AMENDATORY AGREEMENT

SUBJECT: High Line Canal Trail Change Order

PROJECT: High Line Canal Trail Underpasses – Hampden/Colorado (201629357)

-  Approximate Relocated Underpass Location
-  Approximate Additional Topo Survey Area

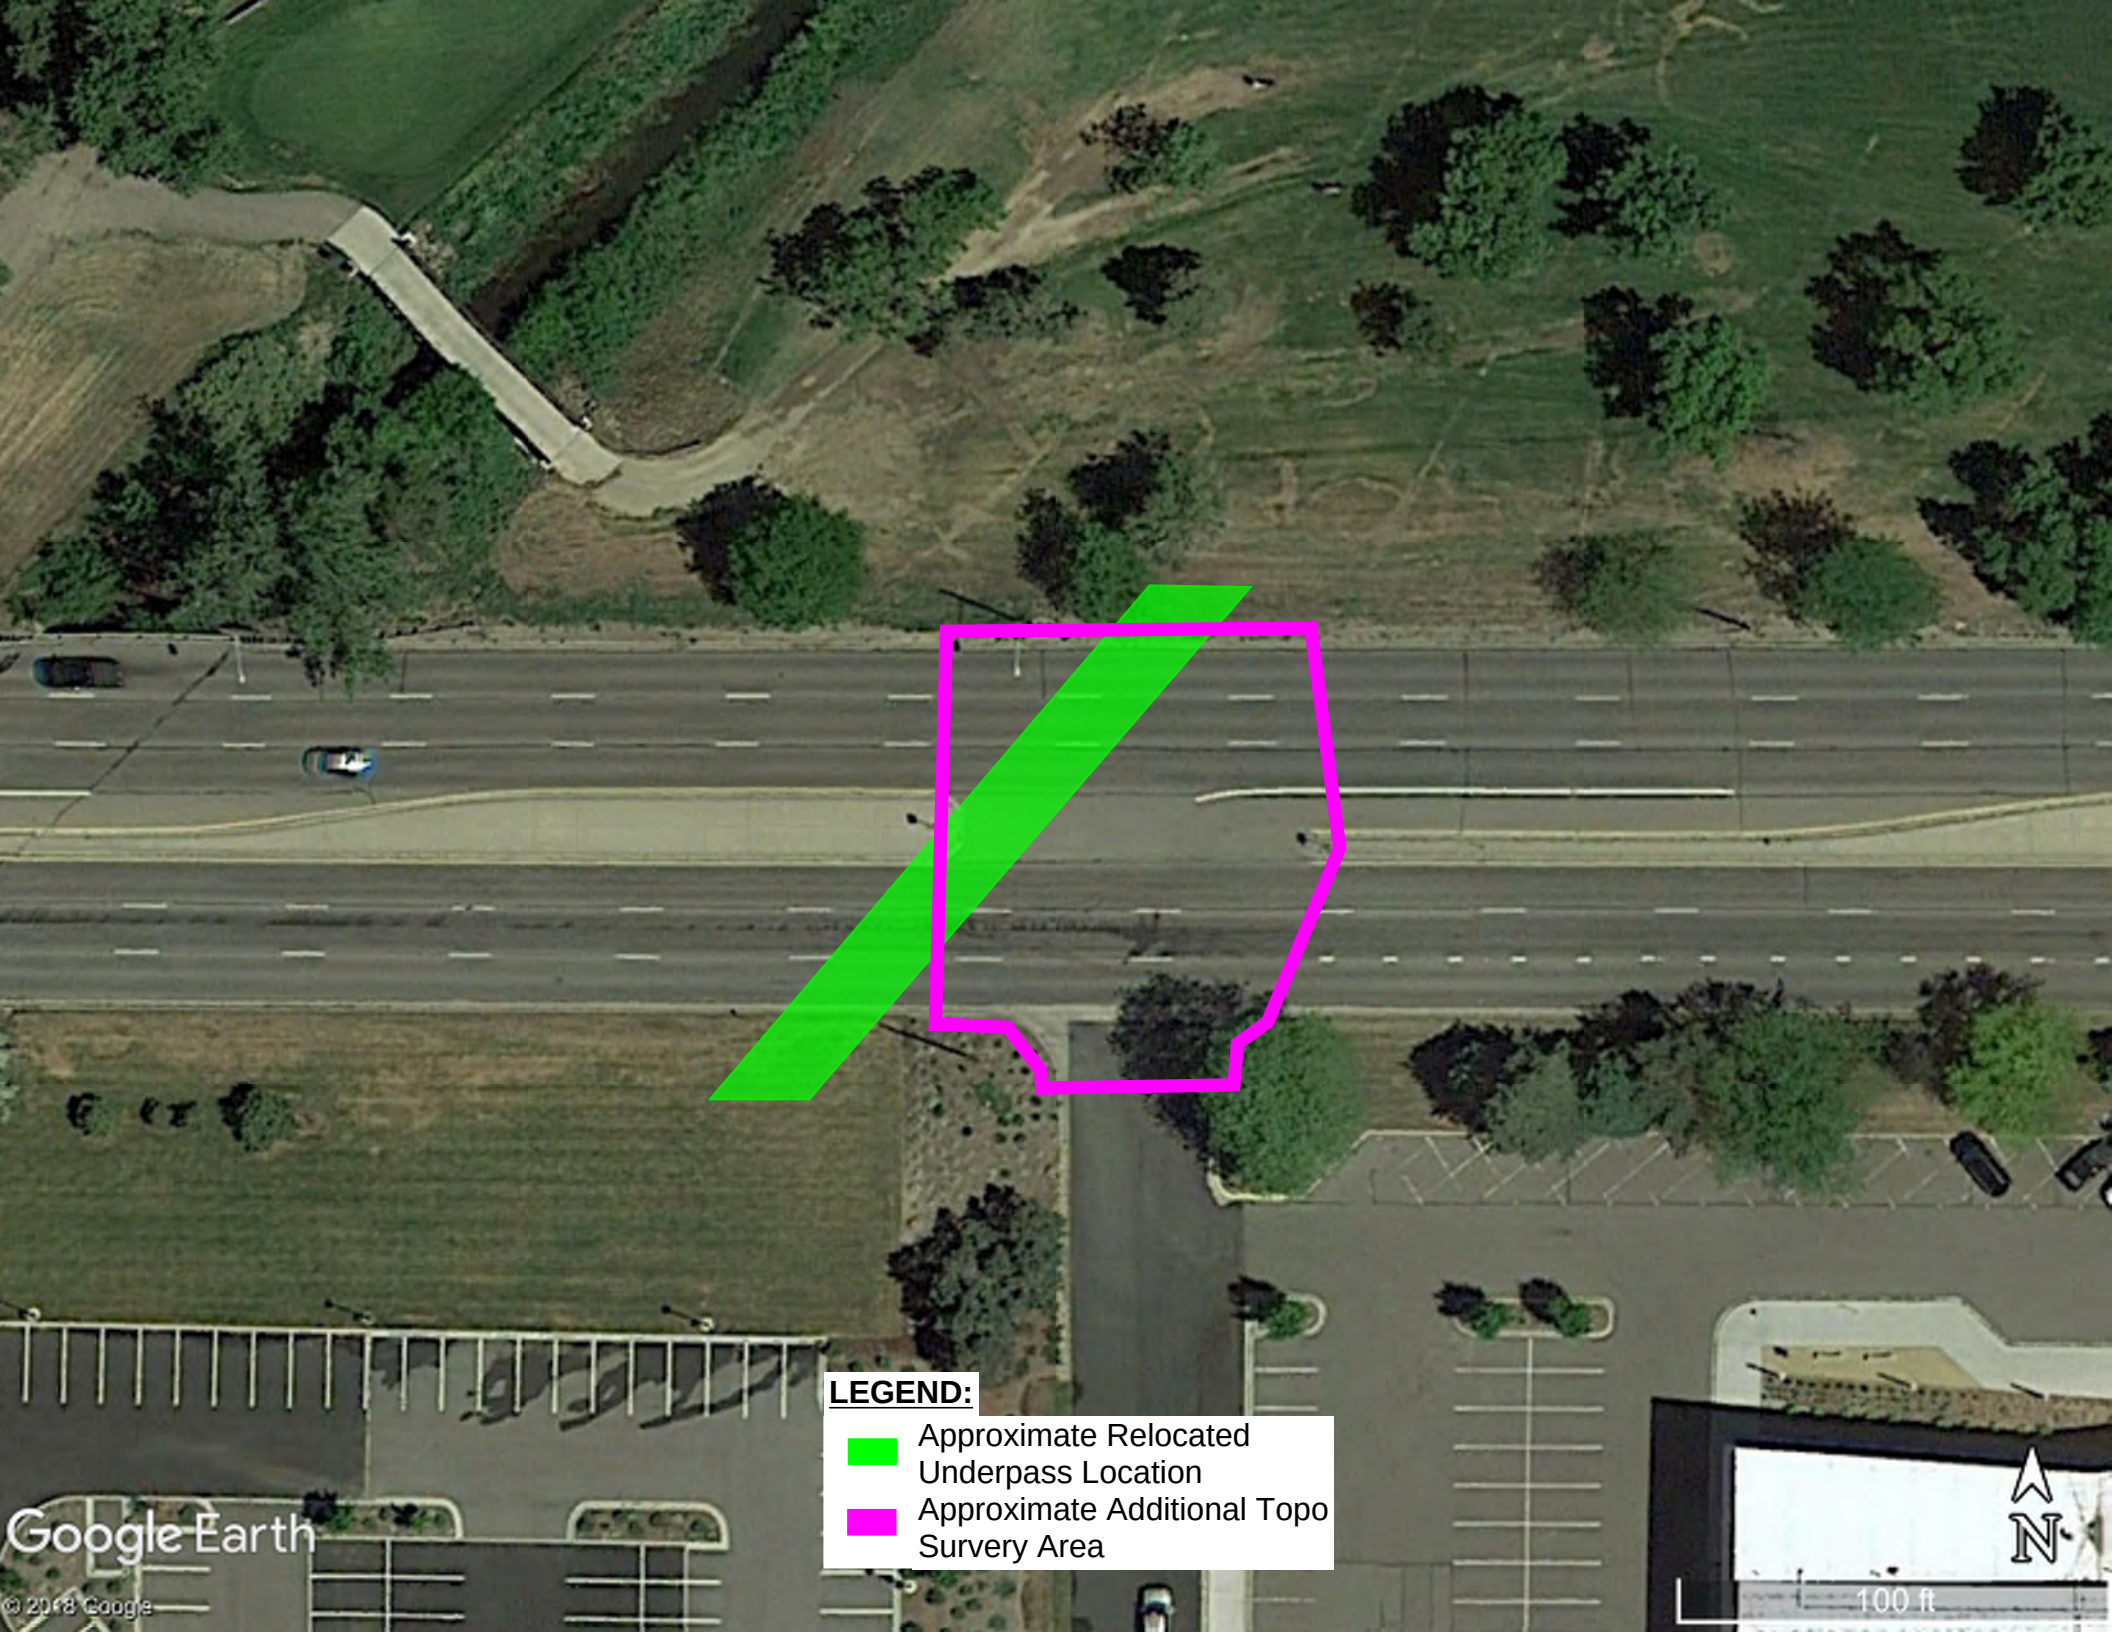
Provide supplemental topographic surveying for the area shown on the attached survey limits map to suitable for design purposes. Map will be a 1-foot contour map supplemented with spot elevations where necessary and will be appended to map previously prepared for the project. Sprinkler heads and other visible irrigation appurtenances locations, as indicated on maps provided, will be surveyed within the utility locating limits, outlined in blue and depicted on the attached map.

HLC TRAIL - HAMPDEN/COLORADO HAMPDEN UNDERPASS EXHIBIT		
Designer:	EMG	Structure Numbers
Detailer:	SPC	
Sheet Subset:	TRAIL	Subset Sheets: TR 6 OF 21

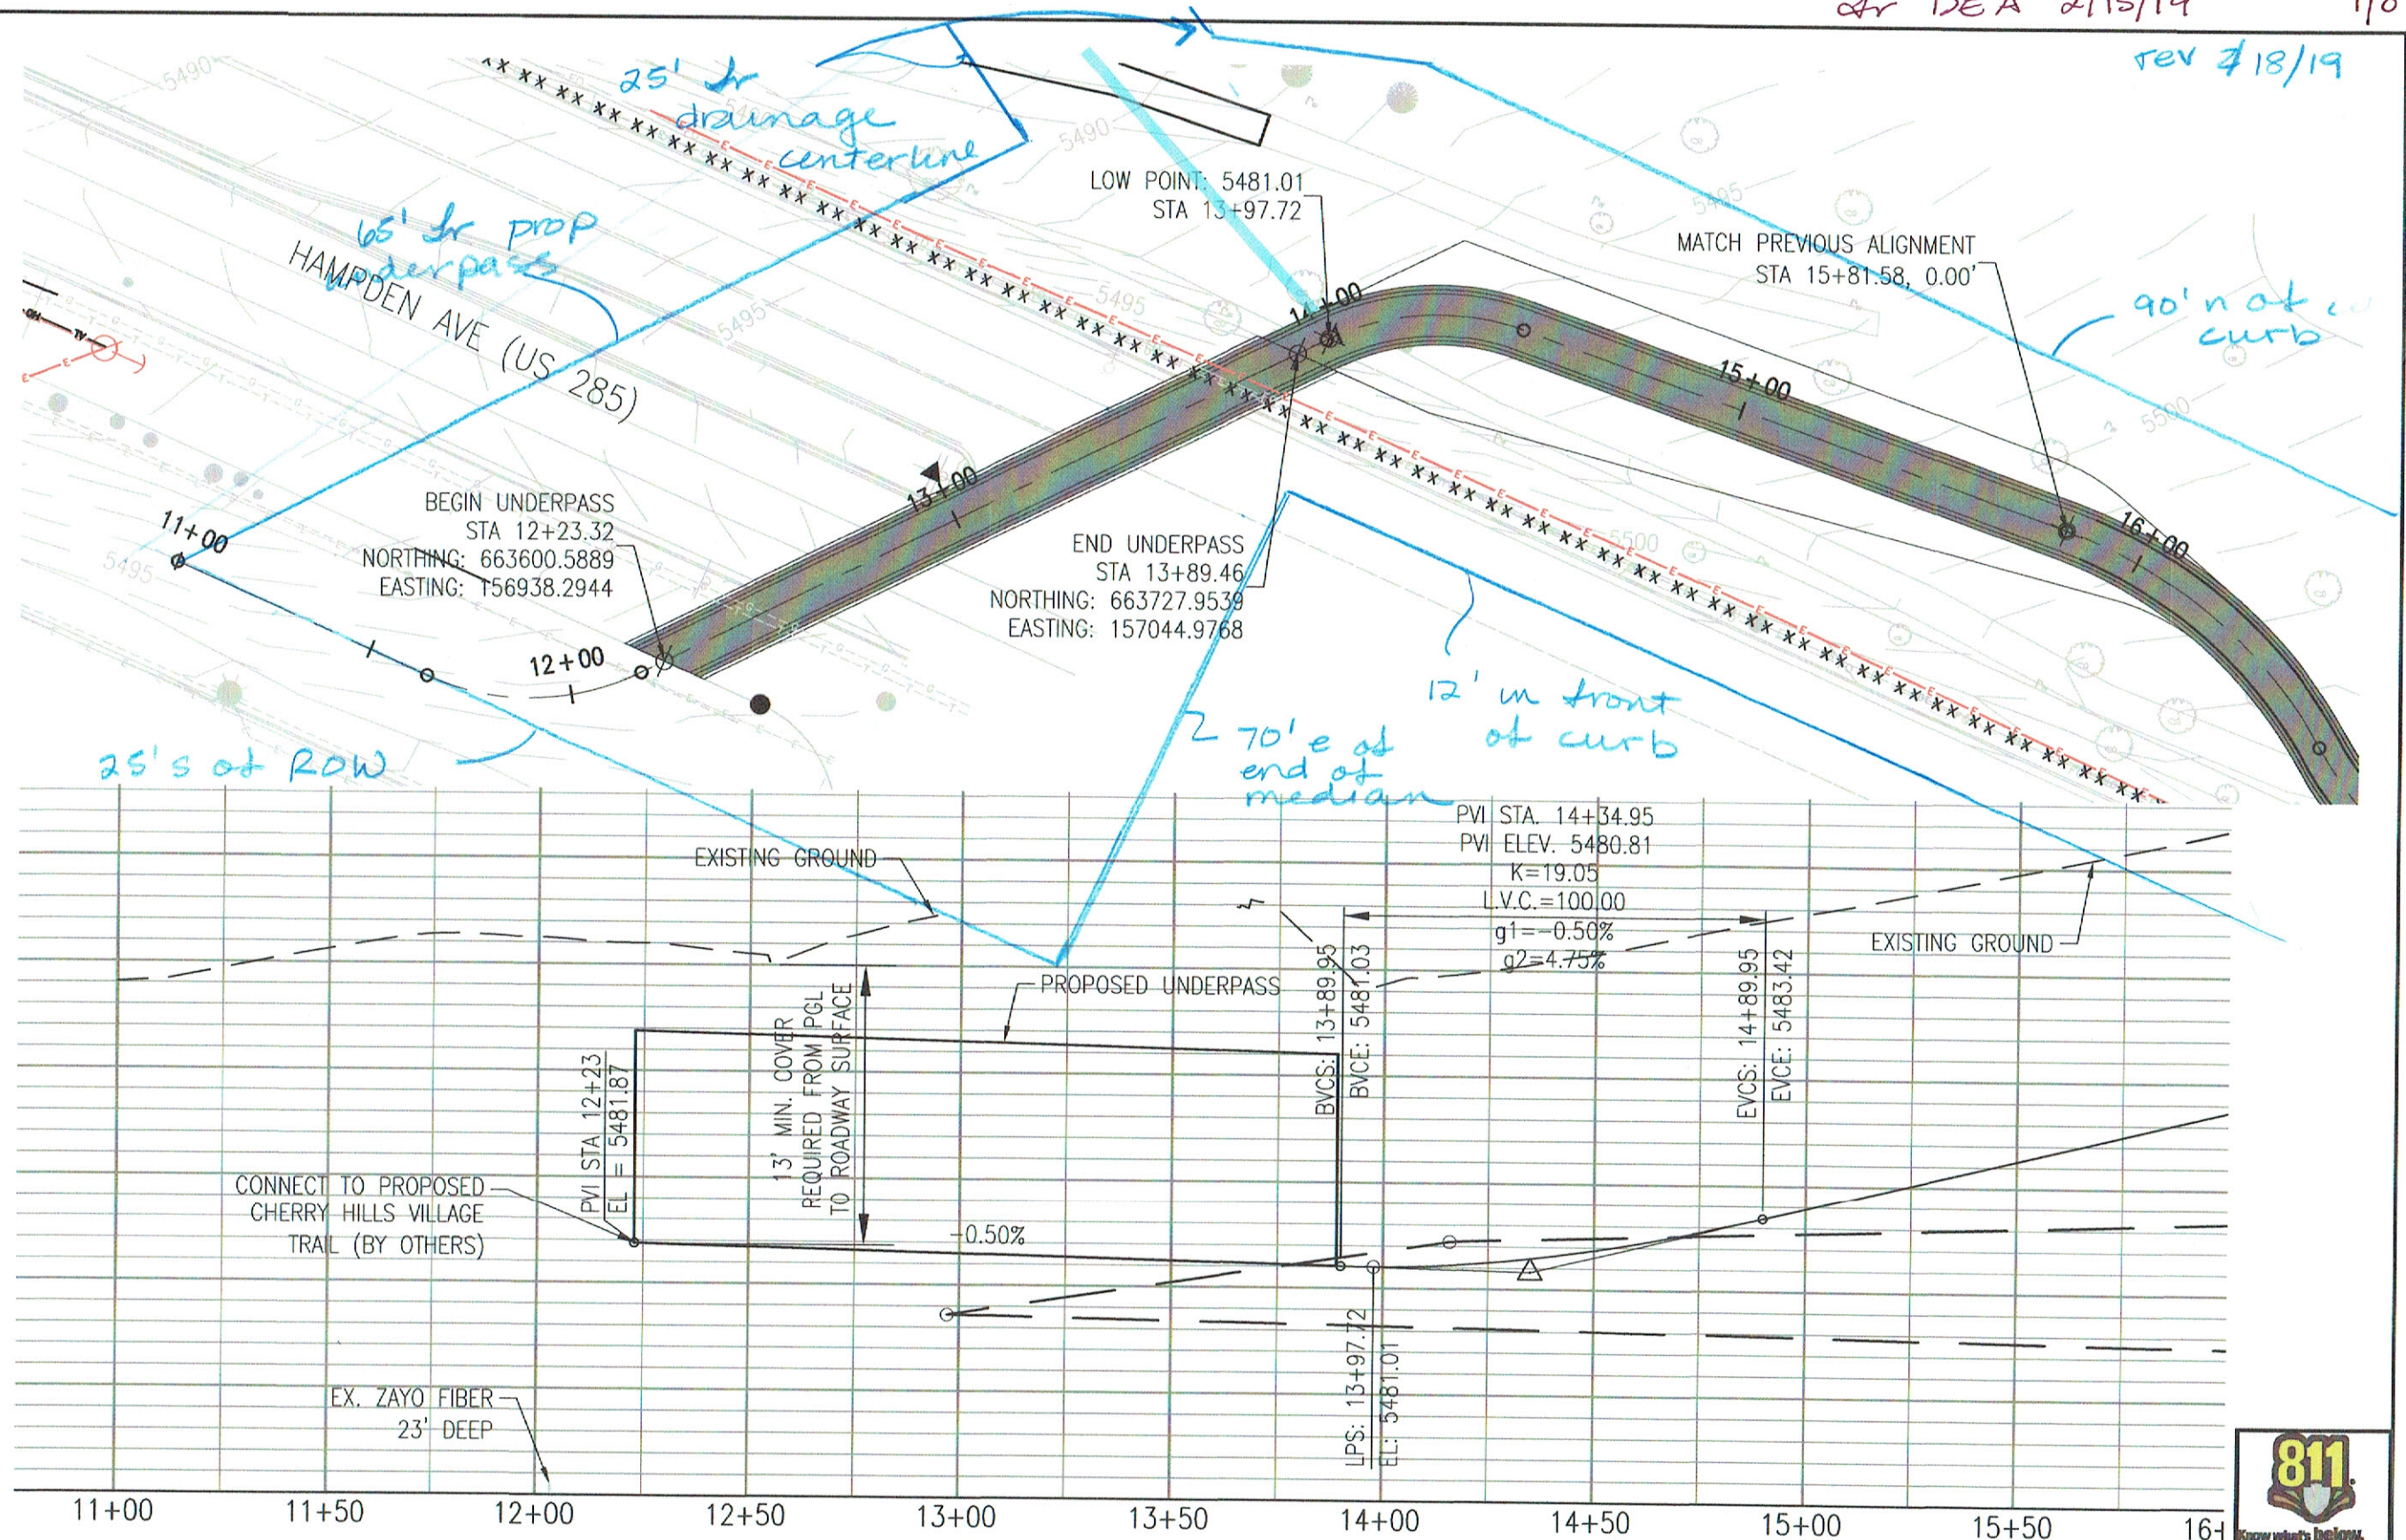
- Relocation of the Hampden Ave Underpass based on coordination with Cherry Hills Village requiring revisions to both our 30% documents and Draft 90% documents including additional topographic survey and geotechnical borings (affected parties: DEA, Yeh, HKS)

This letter presents Yeh and Associates, Inc. proposed scope of work and estimated project costs for providing additional geotechnical services. We understand the location of the proposed box culvert has moved to the east approximately 150 to 200 feet of the previous design location. As a result, two additional geotechnical borings are needed. The following additional services are proposed.
